RESOLUTION NO. 2020- 216

A RESOLUTION AUTHORIZING THE ISSUANCE OF AN AMENDATORY SUPPLEMENTAL CHANGE ORDER NO. 1 TO CONTRACT NO. C20-0059, ISSUED TO RUMSEY ELECTRIC CO., CONSHOHOCKEN, PA, IN THE AMOUNT OF \$54,312.50.

Amendatory Supplemental Change Order No. 1
Contract No. C20-0059
LED Street and Area Lighting VMEU – Distribution Division
Rumsey Electric Co., Conshohocken, PA

REQUEST FOR CHANGE ORDER

Figure # 3 – EXAMPLE OF 130 W FIXTURE FLOOD LIGHT (WITH VISOR)

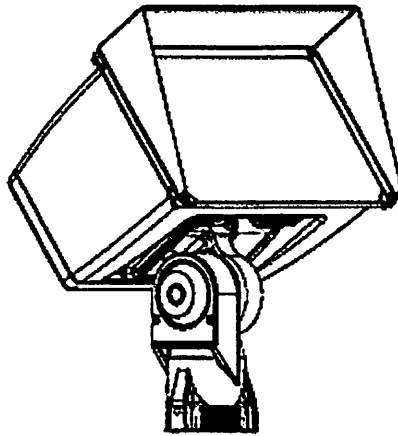
In the waning hours before award, we found there was an error in the evaluation for minimum lumens specified in this item.

I originally thought there was an error in the technical part of the specification. I felt it would have been improper to make a recommendation to award this item if there might be an error in the technical data provided for this item. Which was why I originally thought to just reject all bids for this item and look to re-advertise later for this.

Since then, I found the technical data (16,000 Lumens) in the spec was correct.

- g) Input wattage (@ 120V): Shall be < 130 W (maximum);
 - h) Lumens Maintenance at 50,000-hrs: Shall be > 90% at 25°C Ambient;
 - i) Lumen Output: Shall be > 16,000 (minimum) at 25°C Ambient @ 4,000K;
